Service Bulletin

PRELIMINARY INFORMATION

Subject: Warm Air Exhausting from Driver and/or Passenger Front Seat Back into 2nd Row Seating Area Causing Occupant Discomfort

Models: 2015-2019 Cadillac Escalade Models
2014 Chevrolet Silverado 1500
2015-2016 Chevrolet Silverado, Suburban, Tahoe
2014 GMC Sierra 1500
2015-2016 GMC Sierra, Yukon Models
Equipped with Heated and Cooled Seats - Driver and Passenger Front (RPO KB6)

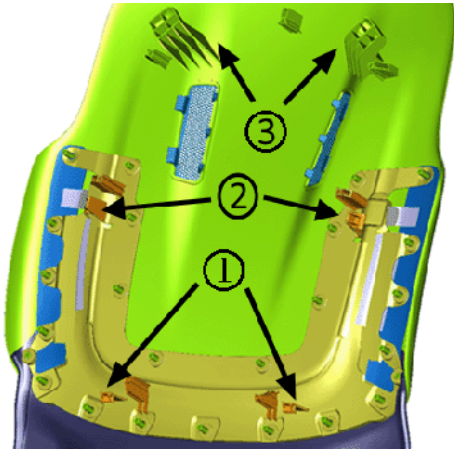
Some customers may comment on warm air exhausting from the driver/passenger front seat back into the 2nd row seating area, causing occupant discomfort.

The cause of this condition may be that during cooled seat operation, a direct flow of warm air exhausts from the upper seat back ventilation heating/cooling blower thermal exchange blower unit.

It has been found that removal of the exhaust duct (1) on the upper seat back ventilation blower allows for a less direct air exhaust and disperses the warm air more thoroughly within the seat back cushion. Remove the upper ventilation blower duct from BOTH the driver and passenger seats using the following steps:

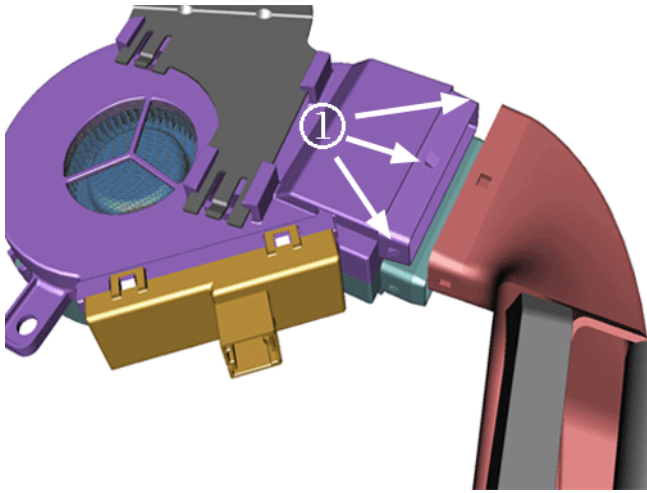
Caution: To help avoid damage to the seat back finish panel, after detaching the lower bungee clips, carefully reach behind the finish panel from the bottom to locate the flat of the lower retainer hooks (1). While pushing up on the flat of the hook, push inward on the panel in the area of the hook to release. Once the lower retainers are released, pull down on the back panel to disengage the upper rigid retainer hooks (3). Detach the side retainer hooks (2) by pushing inward and toward the center of the seat, one side at a time.

1. Starting on the driver or passenger front seat, remove the front seat back cushion finish panel. Refer to *Front Seat Back Cushion Finish Panel Replacement* in SI.

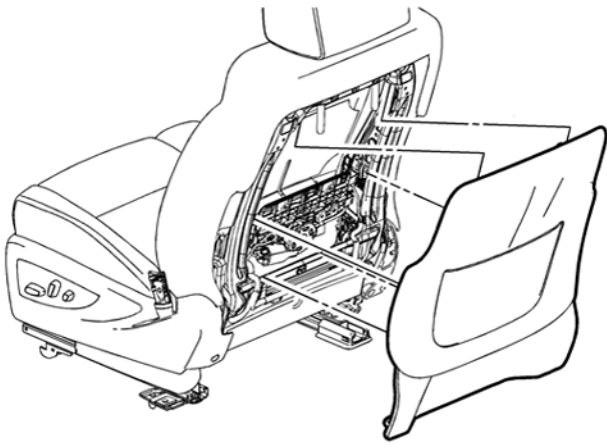
2. Locate the ventilation blower exhaust duct. Depending on the vehicle, the duct may look like either example shown in the graphic above.

3. Grab and twist the ventilation duct to release the top and side retaining tabs (1), and remove the duct from the vehicle.
